## RESPONSE TO REQUEST FOR ADDITIONAL INFORMATION

### APR1400 Design Certification

Docket No. 52-046

RAI No.: 527-8686  
SRP Section: 03.11 - Environmental Qualification of Mechanical and Electrical Equipment  
Application Section: 3.11  
Date of RAI Issue : 10/21/2016

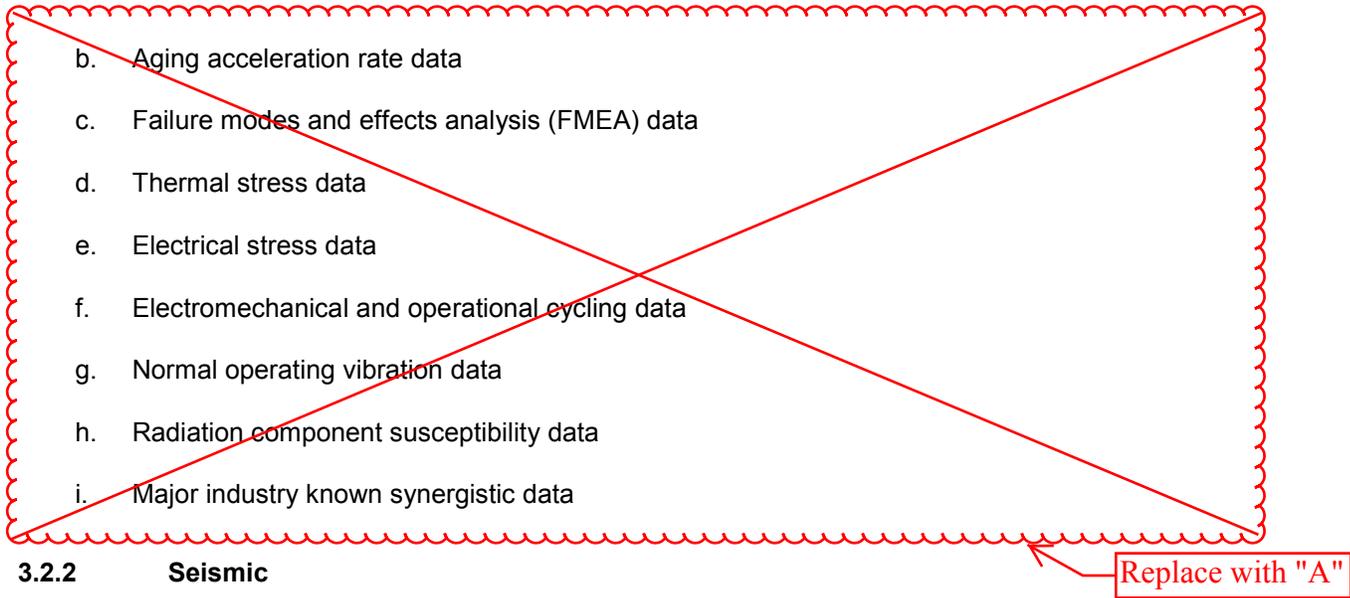
- a) IEEE Std. 323-2003 Section 6.3.1.8.1, "Natural aging," states that natural aging may be supplemented by analysis to account for differences between the specified service and the natural aging conditions to justify the qualified life of the sample.

Please discuss how natural aging supplemented by analysis addresses the end-of-installed-life condition and demonstrates that the equipment remains functional during and following design basis events, in accordance with 10 CFR 50.49(e)(5)

Replace with "A"

The natural aging will be conducted in accordance with 10CFR50.49 and Section 6.3.1.8.1 of IEEE Std. 323-2003. If naturally preconditioning the equipment to end-of-life condition is not practicable, shorter life can be designated. In this case, the equipment shall be replaced at a specified interval. Analysis is performed to verify that natural aging conditions are at least as severe as the intended service condition. In the end, qualified life is determined based on the designated life when analysis and DBA testing are successfully completed.

Natural aging can be used for type testing provided that

- a. Operating data of the equipment is available
- b. Operating and maintenance/replacement records are available
- c. Operating conditions are at least as severe as intended service condition
